Gatwick Airport Northern Runway Project

Response to the Examining Authority's Written Questions
(ExQ2) – Case for the Proposed Development

Application Document Ref: 10.56.1

Fig. A

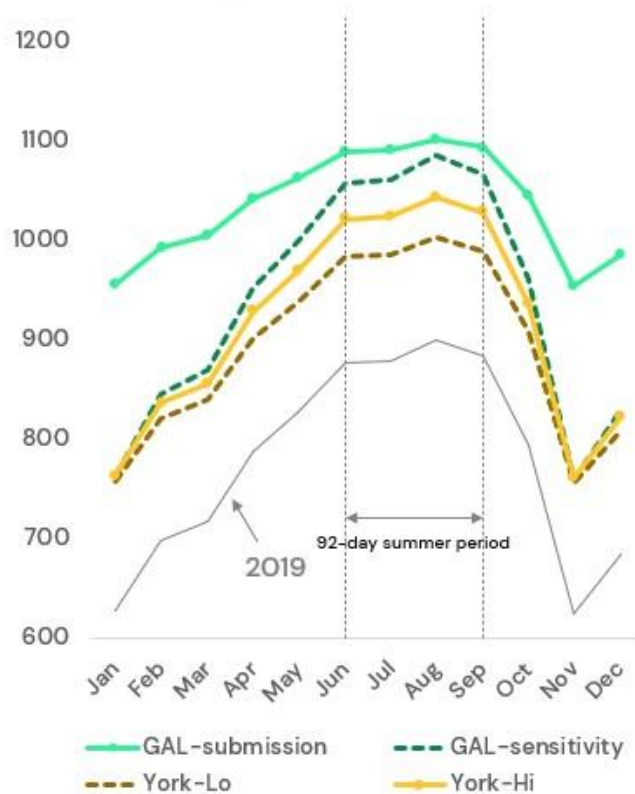
With respect to the Noise Envelope and the sensitivity test implications, it is clear that, if the 92 day summer period throughput used by York for 2032 was correct and growth was lower than the Applicant's submission predicts (as depicted in Figure A below), then noise forecasts in this year would also be lower (as suggested in [REP5-081](#) paragraph 5.8.70). But the York assumption of lower growth in 2032 is based on the incorrect assumption that the absence of Charlie Box is acting as a constraint to runway movement rates and thus airport growth. The Applicant has explained in [REP6-091](#) Section 2.4 why this is incorrect and that growth will not be constrained as York maintain. It therefore follows that noise levels in 2032 are likely to be as the Applicant's submission predicts and setting a noise envelope at the York 2032 growth level would be inappropriate.

Fig. B

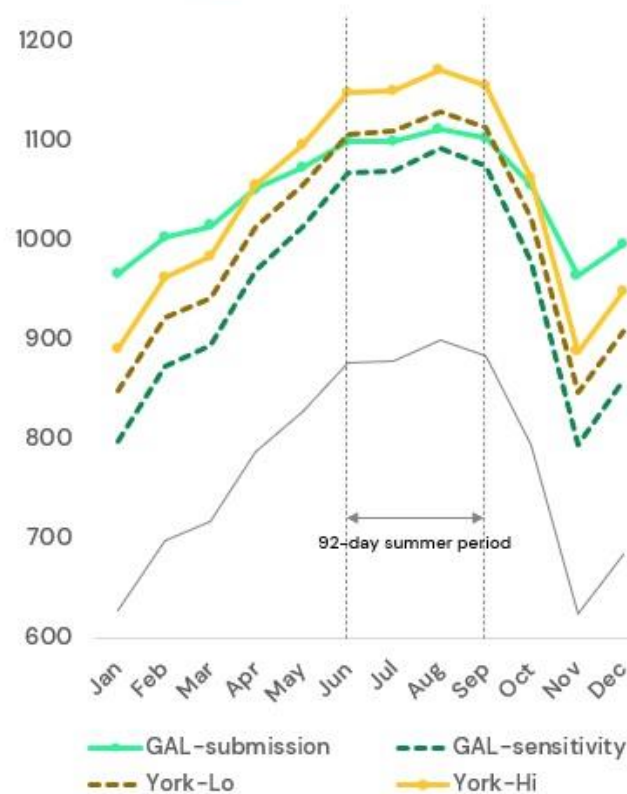
It is also clear that in 2038, both the York Low and High cases produce a greater noise footprint than the Applicant's submission case by virtue of having more movements in the 92 day summer period (see Figure B below). This would require a larger noise envelope in 2038 for the York cases than with the Applicant's case.
